## Product Change Notice (PCN)

**PCN Number:** PCN-0374184R-01

**Product(s) Affected:**  
**CEP-1162**

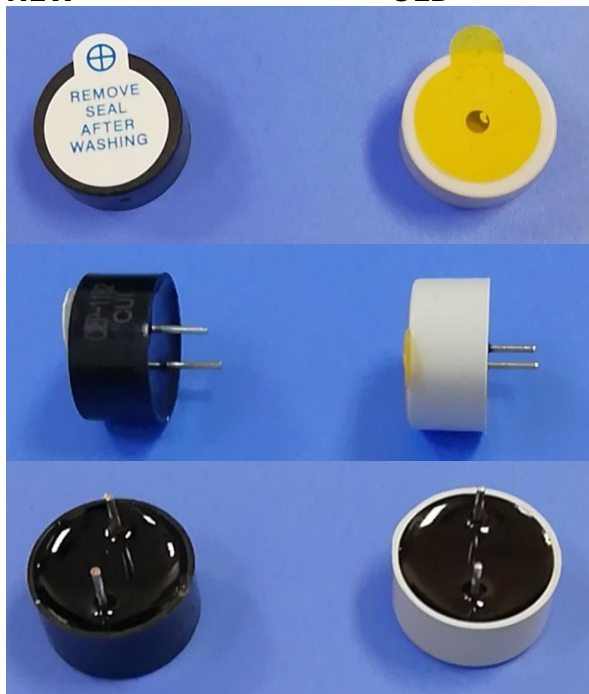
**We are upgrading the plastic housing from PBT to PBT+30% glass, and this is to achieve UL94V-0 Flame retardant level. This is a higher level than the original which was UL94V-1. The color will also be changing from grey to black.**

- Plastic change from PBT to PBT +30% Glass
- Housing color from grey to black
- Db from 80 to 85
- Operating temp now -40 ~ 85 instead of -20 ~ 85
- Storage Temp now -40 ~ 90 instead of -30 ~ 90
